## Technical change to RS and RSM modules

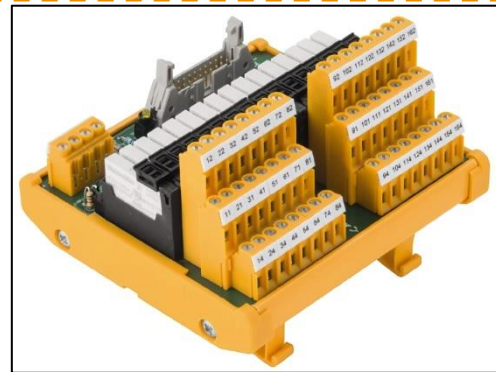
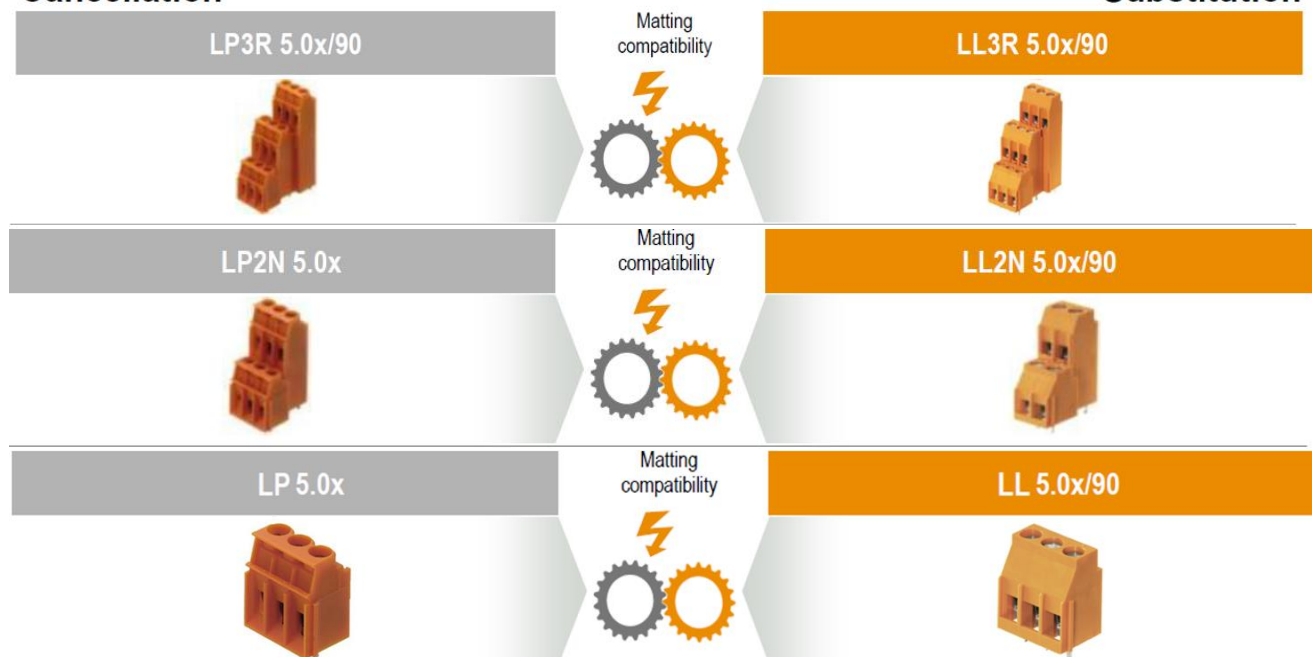
Articles on Section 5 were provided in the past with LP, LP2N, LPK2N and LP3R connectors. Furthermore they were delivered with Dekafix.

Based on continuous improvement the LP, LP2N, LPK2N and LP3R connectors with Dekafix will be replaced by LL, LL2N, LM2N and LL3R connectors with pad printing technology. Furthermore, to fulfill with UL approvals, the product label has been changed to include the UL logo with its file number (e.g. ) and the appropriate UL rated values.

Obsolescence of LP, LP2N, LPK2N and LP3R connector range and addition of **UL-recognized** approvals () on the label for these products, making each interface UL recognized.
